BZA Packet

MEETING AGENDA
CITY OF MOUNTAIN BROOK
BOARD OF ZONING ADJUSTMENT
AUGUST 15, 2016
PRE-MEETING: (ROOM A106) 4:30 P.M.
REGULAR MEETING: (ROOM A108) 5:00 P.M.
CITY HALL, 56 CHURCH STREET, MOUNTAIN BROOK, AL 35213

Report to the Board of Zoning Adjustment

Report to the Board of Zoning Adjustment

LOAN CLOSING SURVEY

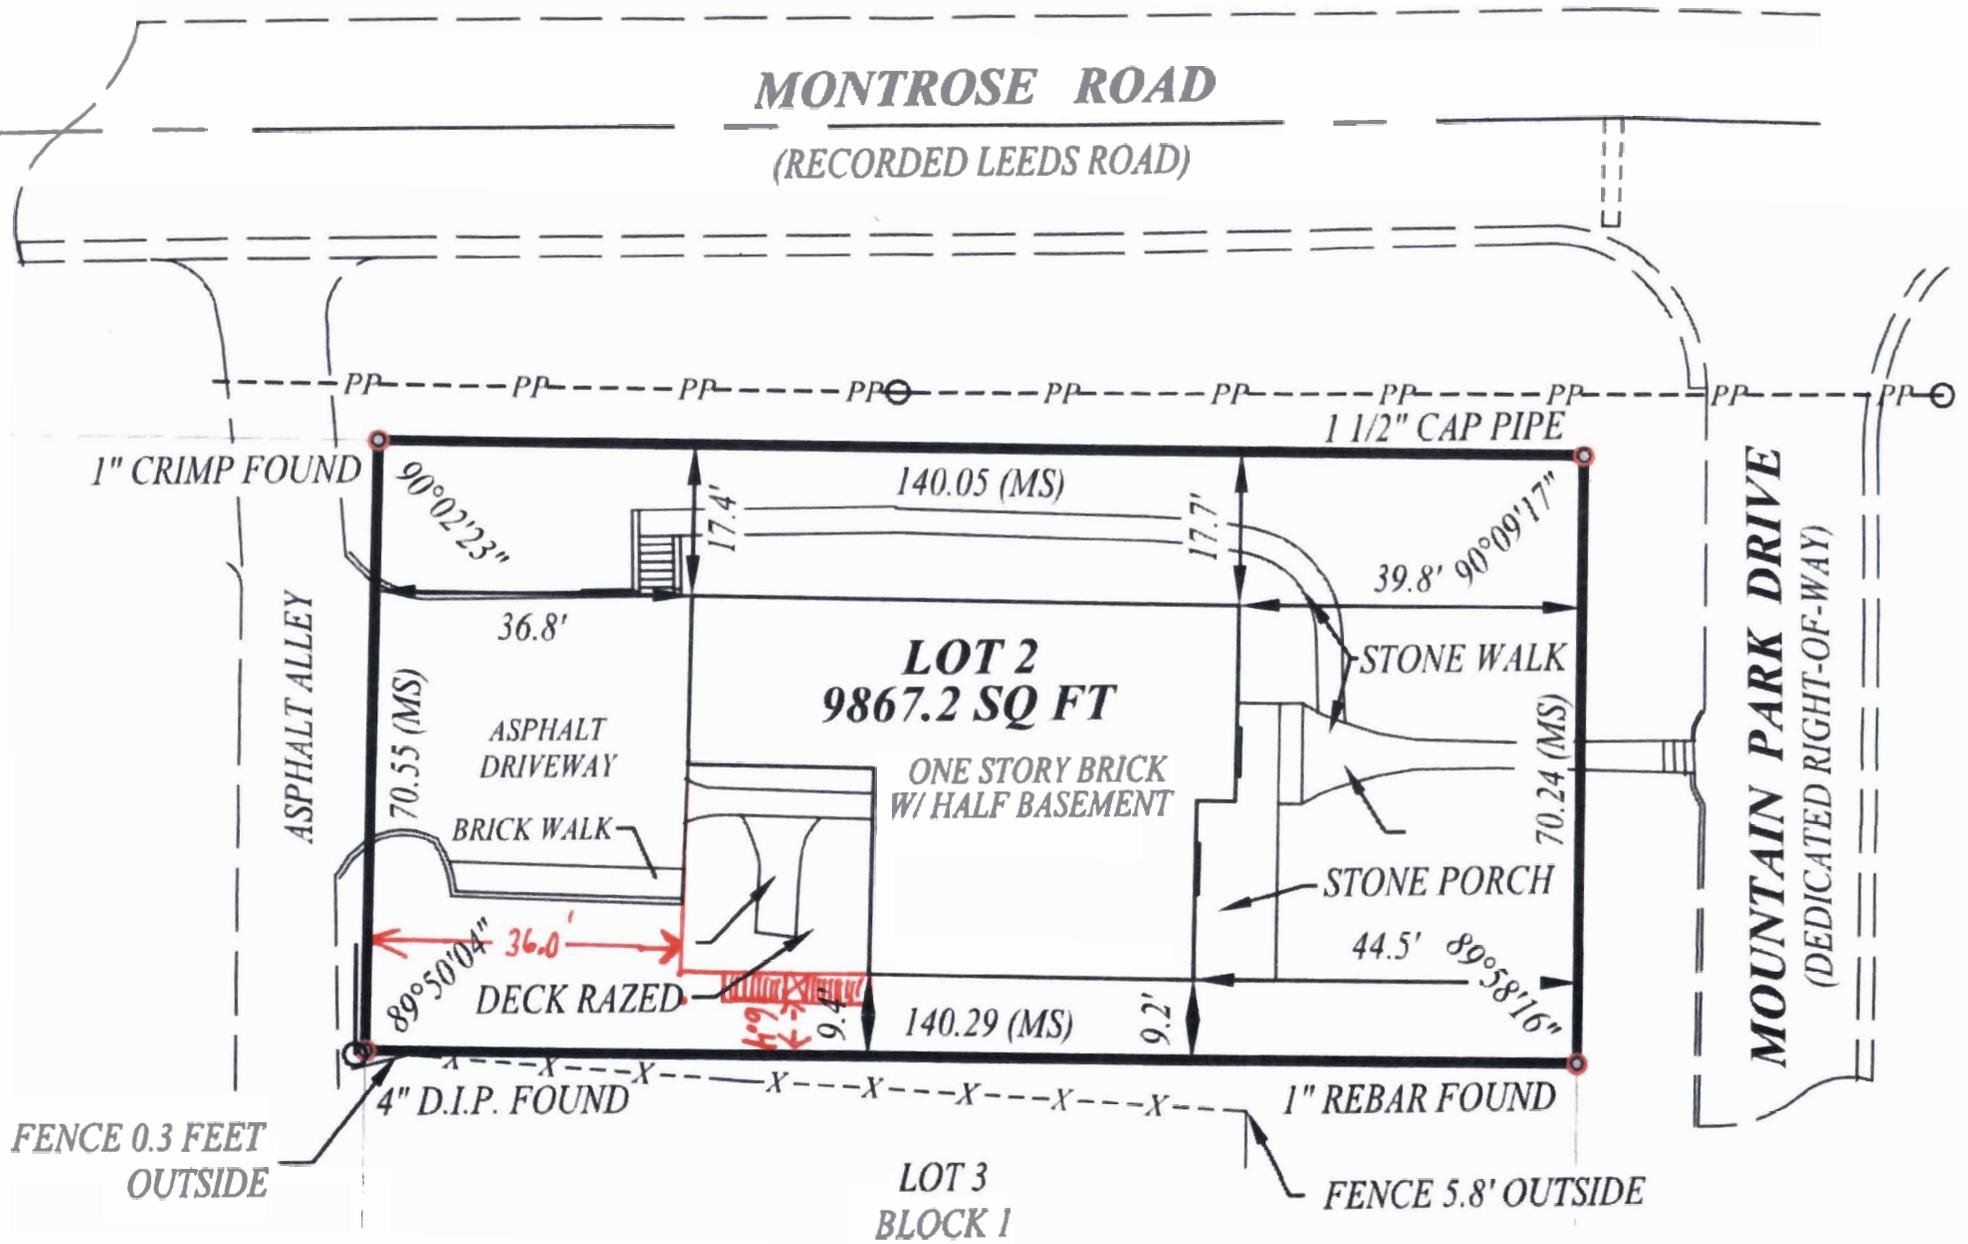
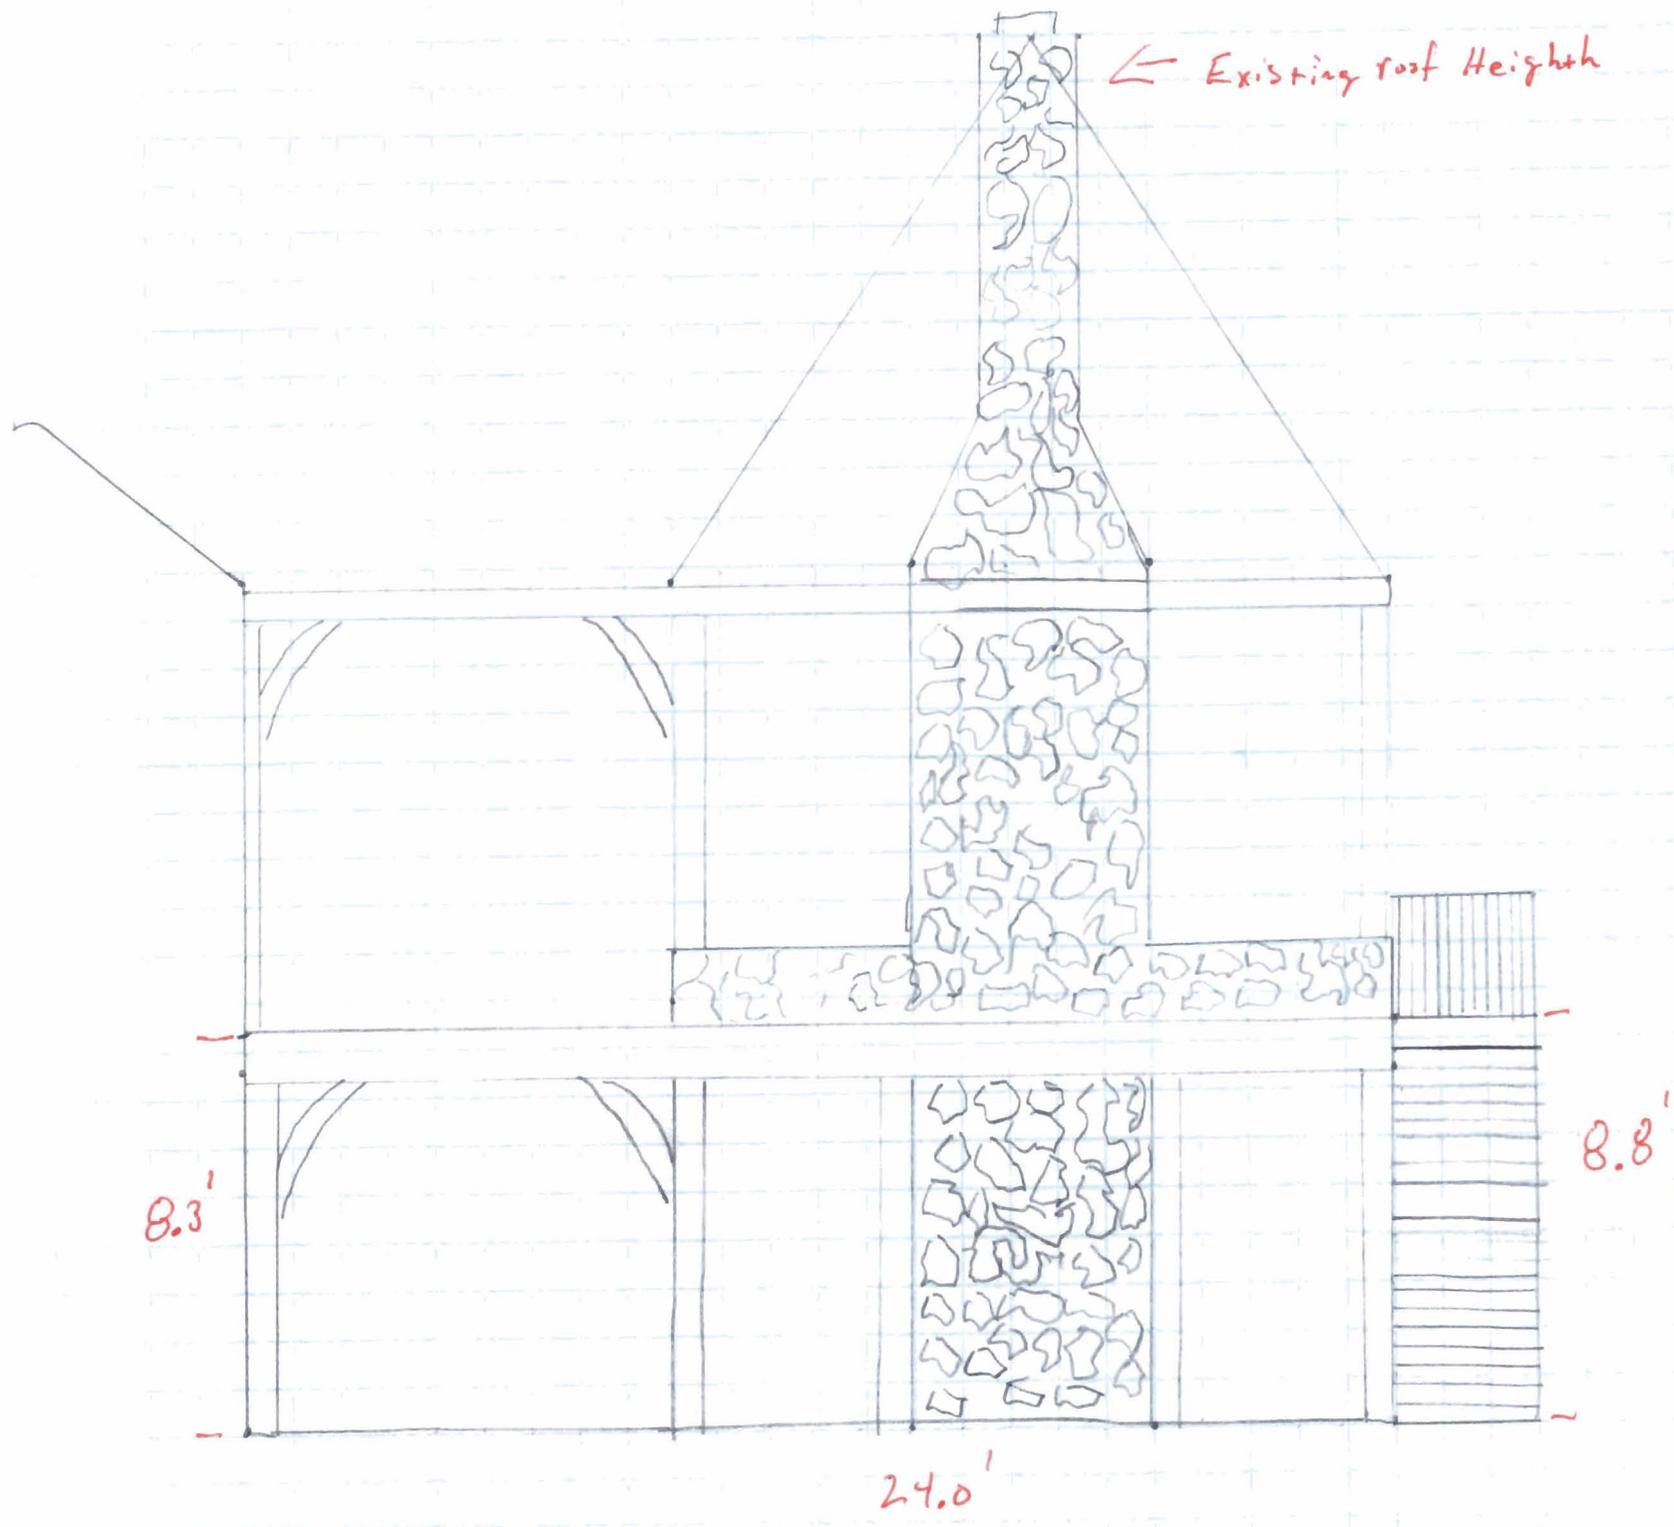
The hardships in this case are the lot width (70 feet in lieu of the required 75 feet), the corner lot configuration, and the existing design constraints. The proposal involves replacing the previously existing uncovered deck with a new covered deck, stair and chimney. The previous deck was 9.4 feet from the side property line; the new covered deck will be 9.4 feet from the same (in line with the side of the house) and the new stair will be 6.4 feet from the side property line.

It should be noted that this lot is 0.55 feet over the 70-foot limit which would have qualified it for a reduced side setback of 8 feet, in which case only the stair would have needed a variance.

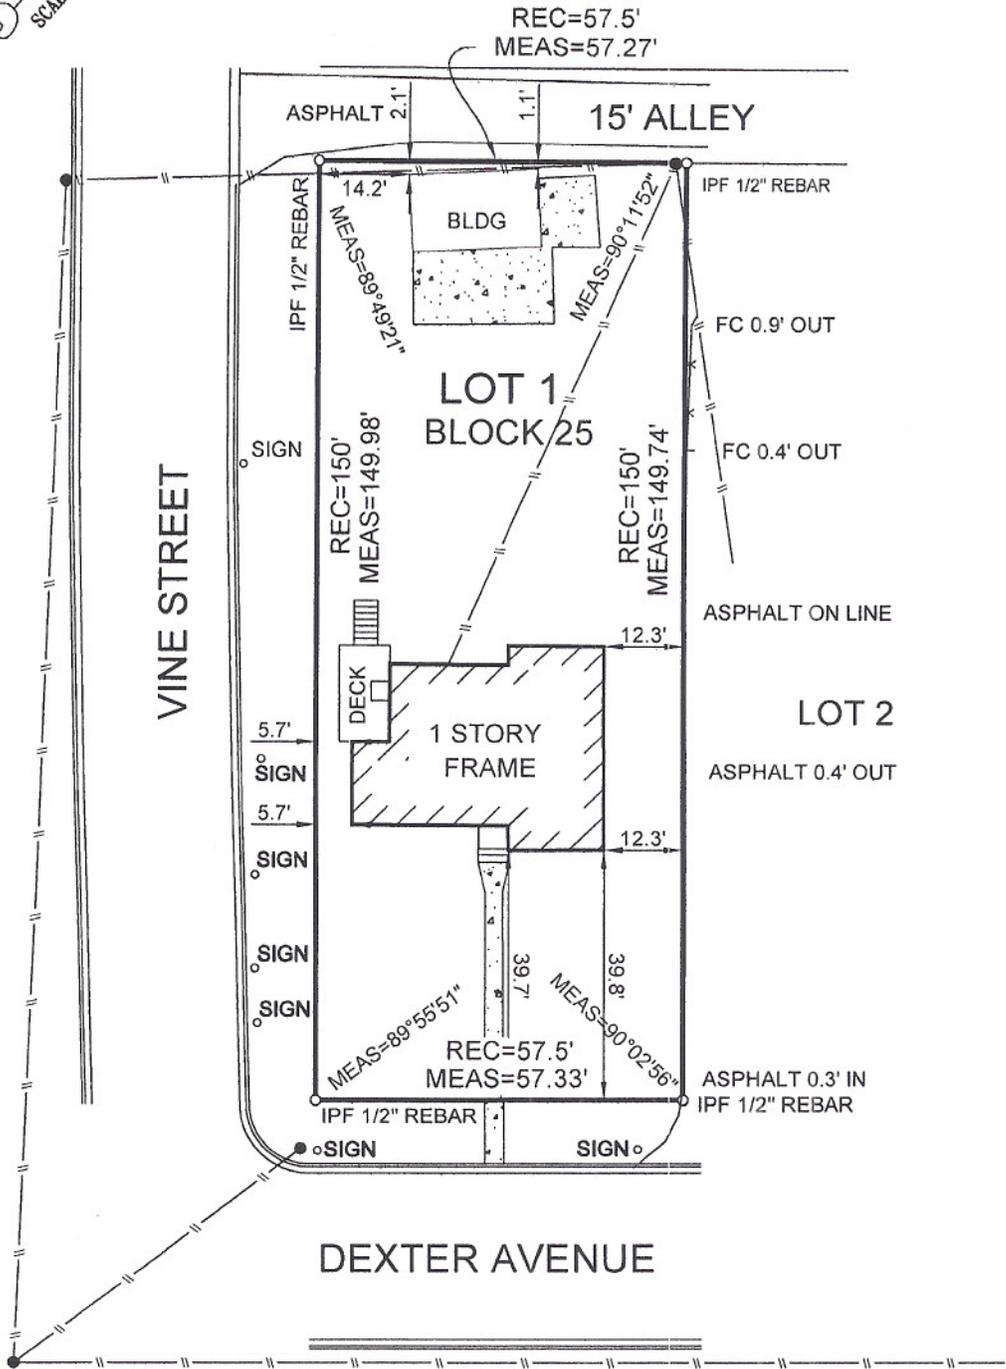
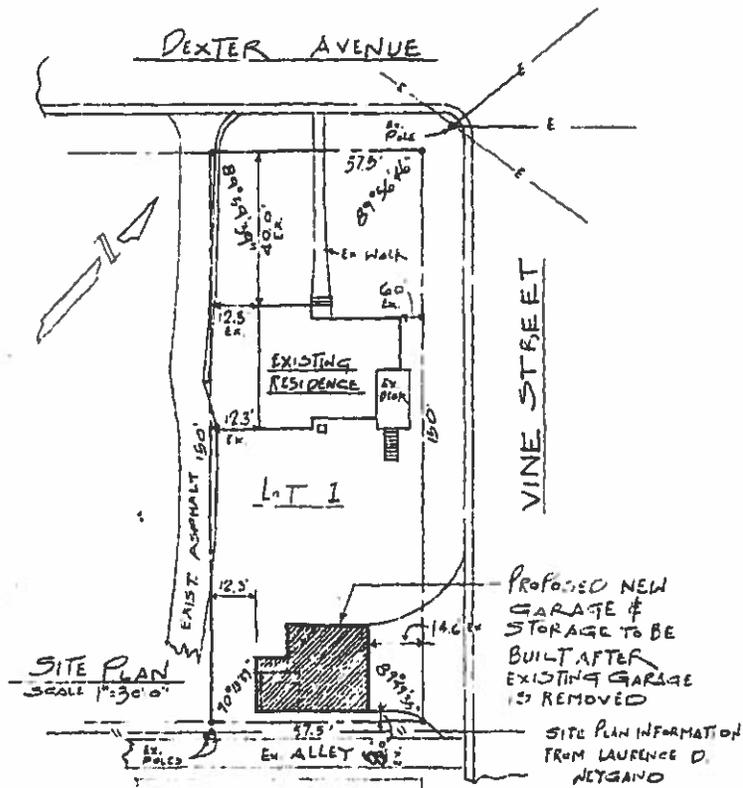
The hardships on this lot are lot size, narrow width (57.5 feet) and the fact that it is a corner lot with a secondary front on Vine Street. Also, due to the fact that its zoning is Res-D it is not eligible for the secondary front setback of 13 feet for which other similar lots in the vicinity (zoned Res-B & Res-C) are eligible. Instead, structures on this lot must maintain 35 feet from the secondary front setback along Vine.

The proposal is to replace or repair/relocate the existing detached structure. The existing structure is 14.6 feet from the secondary front and 2 feet from the rear property line along the alley. Due to the size (approx. 1036 sq. ft.) and the height (25 feet) of the proposed detached building, it is not eligible for the reduced rear setback of 10 feet for smaller accessory buildings.

As to the proposed 8-foot rear setback, 10 feet is required along the same alley for commercial buildings on the same block and given the fact that there is approximately 52 feet between the existing detached building and the principal structure on the lot, there is room to relocate the detached building farther from the rear property line. However, as noted above, if zoned VST District this property would only be required a 5-foot rear setback, so the proposed 8 feet may be a reasonable request.

As to the proposed 12.3-foot interior side setback, it is drawn in line with the principle structure on this lot; but given the opportunity for the new detached building location to conform there may be no reason to allow a 0.2-foot variance for this side.

As to the request to exceed the maximum square footage of 800 square feet, it is not apparent how the lot's inherent hardships of size, width and corner configuration relate to the requested relief from the code requirements for square footage.
